Office Action Summary

10/780,444

BONUTTI ET AL.

DETAILED ACTION

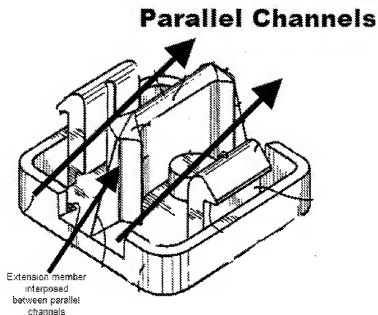
Regarding claim 4, Merritt discloses the first section including a pair of parallel channels (Figure 4, see below).

Regarding claim 5, Merritt discloses the extension member (66) interposed between the pair of parallel channels (Figure 4, see above).

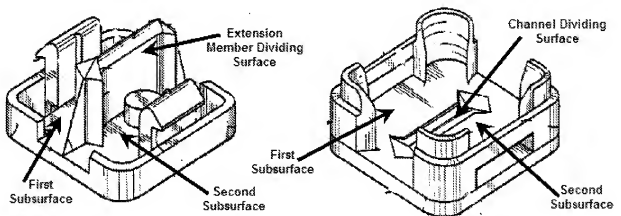
Regarding claim 51, Merritt discloses said extension member divides said first surface into a first first-surface subsurface and a second first-surface subsurface, a channel divides said second surface into a first second-surface subsurface and a second second-surface subsurface (See Figure Below), said first first-surface subsurface is configured to align with said first second-surface subsurface when said first section is bonded to said second section; and said second first-surface subsurface is configured to align with said second second-surface subsurface when said first section is bonded to said second section (Figure 3)
